DESIGN <i>CP</i>	DRAWN BY <i>CP</i>	DART AEROSPACE LTD HAWKESBURY, ONTARIO, CANADA	
CHECKED <i>#</i>	APPROVED <i>#</i>	DRAWING NO. D3016	REV. A SHEET 1 OF 3
DATE 01.05.18		TITLE SEAT FRAME ASSEMBLY	SCALE NTS
A	01.05.18	NEW ISSUE

DRAWING NO. D3016	TITLE SEAT FRAME ASSEMBLY	REV. A	DART AEROSPACE LTD ENGINEERING ORDER	D.E.O. NO. D3016-A-1	SHEET NO. SHEET 1 OF 1	SCALE NTS
DRAWN 1	CHECKED UP	MFG. APPR. RE	APPROVED WAP	DE APPR. WAP		
DATE 10.01.29	DATE 10.01.29	DATE 10.01.29	DATE 10.01.29	DATE 10.01.29	DATE 10.01.29

TO REVISE D3016-11 SADDLE'S HOLE SIZES

D3016-11 SADDLE

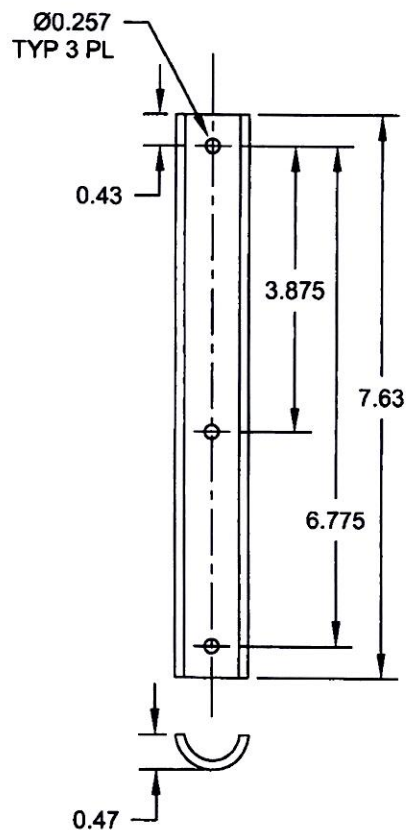
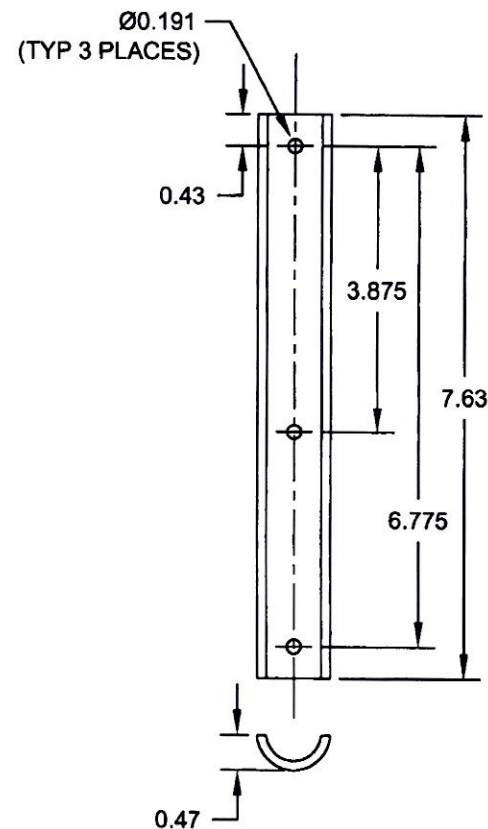
DETAIL D3016-11 SADDLE (SHEET 3): Ø0.257 TYP 3 PL WAS Ø0.191 (TYP 3 PLACES) AS SHOWN:
